FIRE & LIFE SAFETY STUDY

BUFFALO COURTS • PANHANDLE-PLAINS HISTORICAL MUSEUM
MARY MOODY NORTHERN HALL • SYBIL B. HARRINGTON FINE ARTS COMPLEX
VIRGIL HENSON ACTIVITIES CENTER

February 16, 2017

Buffalo Courts 1st Floor Plan

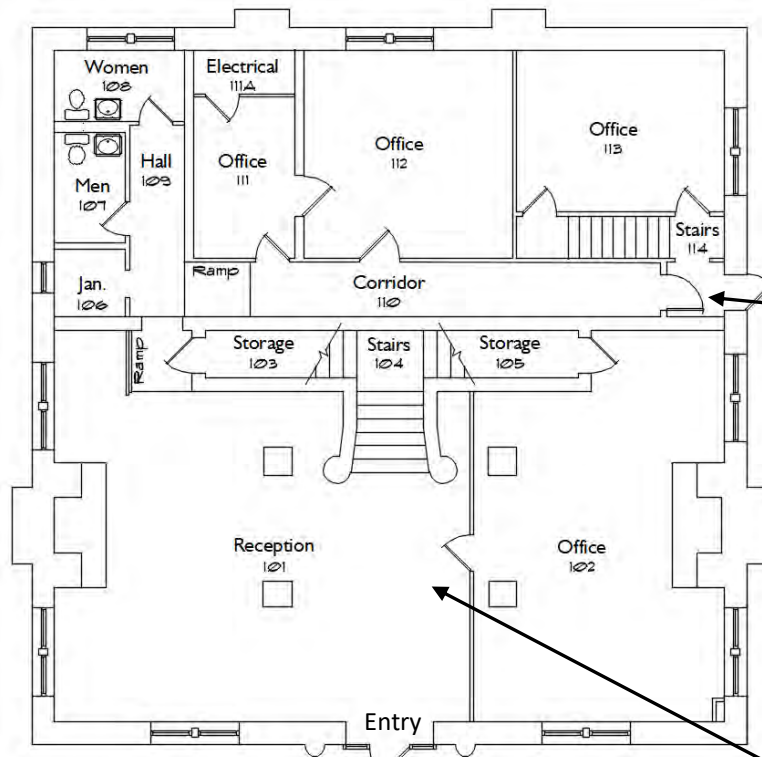
- 1) "The front stairway is unenclosed and not protected.".....(39.2.2.3.1, 7.2.2.5.1.1, 7.2.2.5.2.1, 7.1.3.2 and 8.2)
- 2) "Both stairways discharge into the interior of the building."(39.2.7 and 7.7.2)
- 3) "The front stairway is unenclosed creating a vertical opening.".....(39.3.1.1 and 8.6)

Proposed new frame and door in the hall adjacent to the back stair to provide a direct exit from that stair to the exterior.

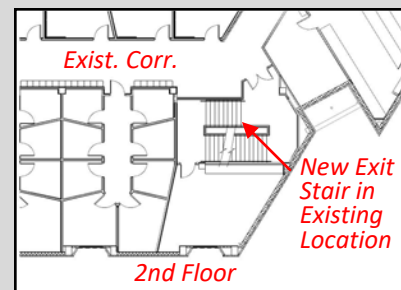
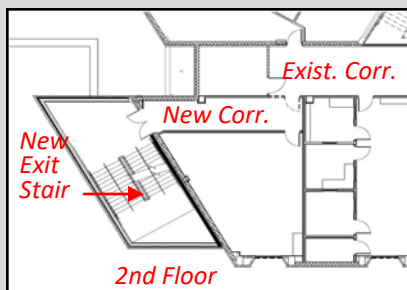
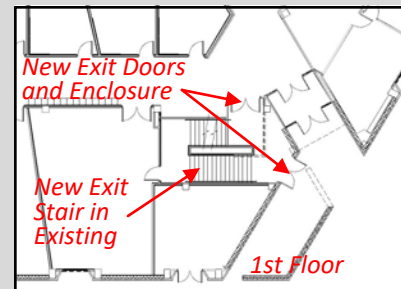
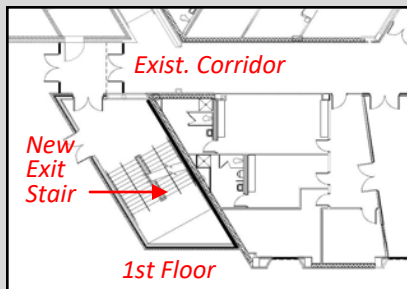
1) "All 3 stairways are unenclosed and not protected." (39.2.2.3.1, 7.2.2.5.1.1, 7.2.2.5.2.1, 7.1.3.2 and 8.2)

CORRECTIVE ACTION:
Remove the existing southwest stairs between the first and second floors. Provide a new stair tower at the southwest corner and rework the existing southeast stair to exit to the exterior.

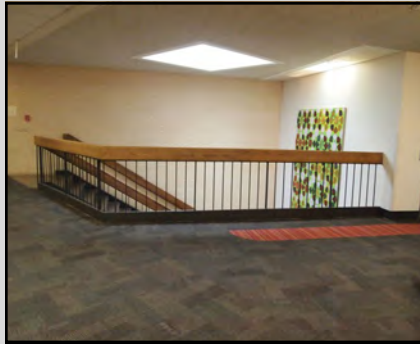
2) "All 3 stairways discharge into the interior of the building." (39.2.7 and 7.7.2)

CORRECTIVE ACTION: . After addition of the new stair tower and revising the southeast stair, two of the three stairs will exit to the exterior.

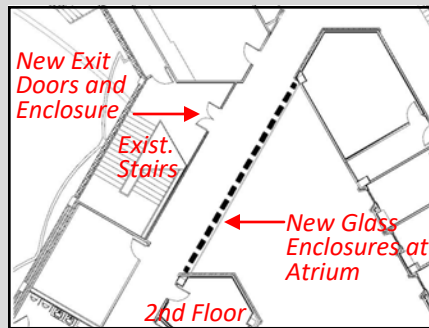
3) "All 3 three stairways are unenclosed creating vertical openings." (39.3.1.1 and 8.6)

CORRECTIVE ACTION: . . .The upper portion of the remaining interior stair will be separated from the rest of the story with a smoke barrier. The atrium will be separated from the second floor level with full height glass enclosures at the open sides.

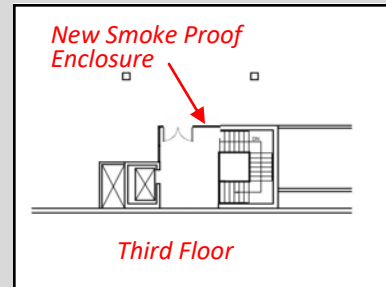
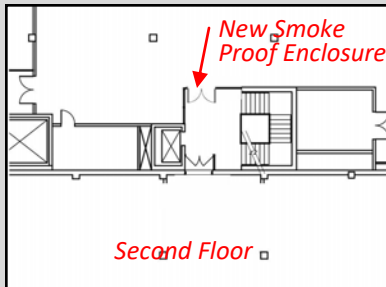
- 2) "The center stair is unenclosed and not protected on the 2nd and 3rd floors."
..... (13.2.2.3.1, 7.2.2.5.1.1, 7.2.2.5.1.2, 7.1.3.2 and 8.2)

CORRECTIVE ACTION: Provide enclosures for the stair at the second and third floors.

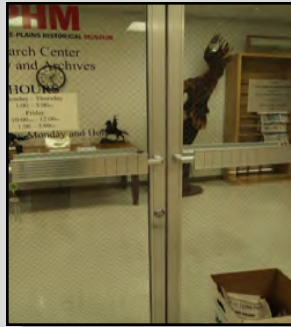
- 3) "There is a lack of exit signs throughout the 1st floor." (13.2.10 and 7.10)

CORRECTIVE ACTION: Provide additional exit signs throughout the first floor.

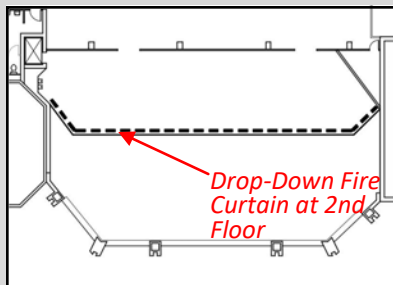
8) "There is a vertical penetration through the ceiling extending in to the first floor adjacent to room W010A."
..... (8.4.4.1 and 8.5.6.2)

CORRECTIVE ACTION: Close vertical penetration with fire dampers.

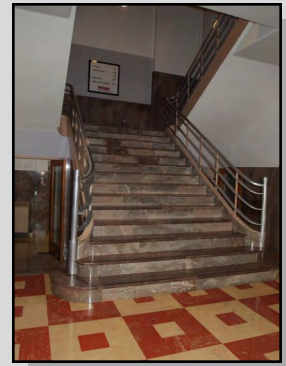
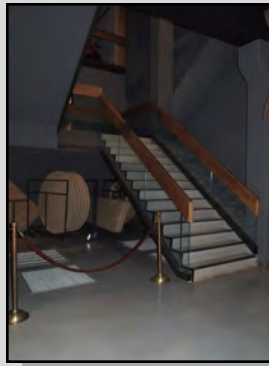
- 9) "There is no separation of the remainder of the building from the communicating space by a 1 hour fire barrier." (13.3.1 and 8.6.6(4))

CORRECTIVE ACTION: Provide a drop-down fire curtain at the second floor level.

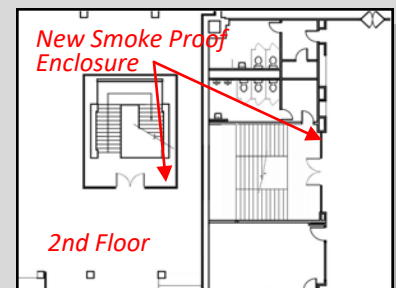
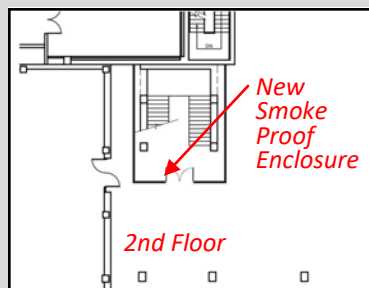
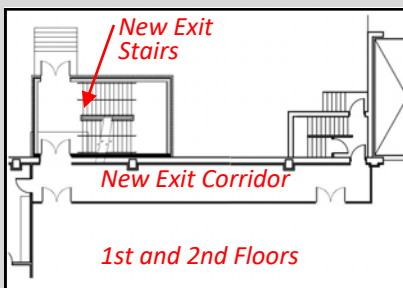
- 10) "The 4 convenience stairs are not separated from the corridors and the building is not protected throughout by a fire sprinkler system." (13.3.1, 8.6.9.1(3), 8.6.9.2(2) and 9.7)

CORRECTIVE ACTION: Provide a fire sprinkler system. Provide new exit corridors on the first and second floors. Provide smoke proof enclosures at convenience stairs at the second floor.

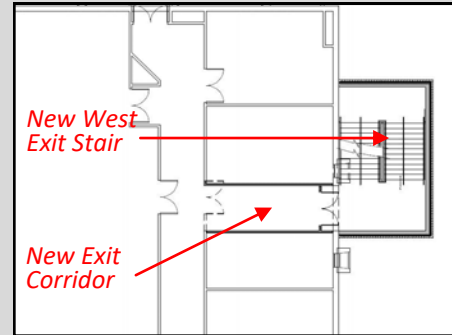
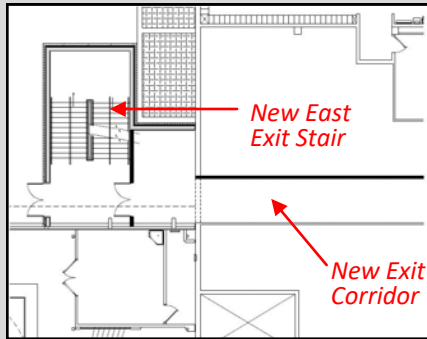
- 1) "Only 1 stair out of 5 discharges directly to the exterior of the building." (13.2.7.1 and 7.7.2)

CORRECTIVE ACTION: Provide two new stair towers on the east and west sides of the building, and rework the existing south stair to exit to the exterior. This will provide four out of five stairs to discharge directly to the exterior.

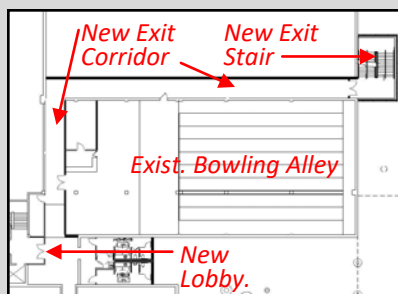
- 2) "The 2 basement stair doors adjacent to the bowling alley lack a 1 hour fire-rating resulting in a lack of stair enclosure." (13.2.2.3.1, 7.2.2.5.1.1, 7.1.3.2.1(1), 8.2.2.2 and 8.3.4.2)

CORRECTIVE ACTION: Provide a new rated stair and elevator lobby in the basement and provide a new exit corridor in the basement leading to the new west exit stair.

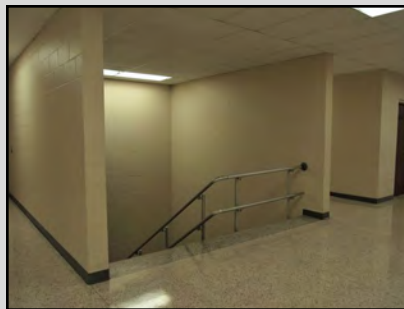
3) "There is a lack of exit signs adjacent to rooms 207, 219 and exit from swimming pool." (13.2.10 and 7.10)

CORRECTIVE ACTION: Provide additional exit signage at locations indicated in the Fire Marshall's report.

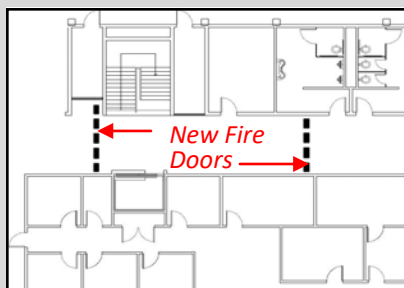
6) "The 2 center convenience stairs are not separated from the corridors and the building is not protected throughout by a fire sprinkler system." (13.3.1, 8.6.9.1(3), 8.6.9.2(2) and 9.7)

CORRECTIVE ACTION: A) Provide full sprinkler system. B) Install fire separation doors on the second floor to separate the existing stairs and elevator from the first floor.
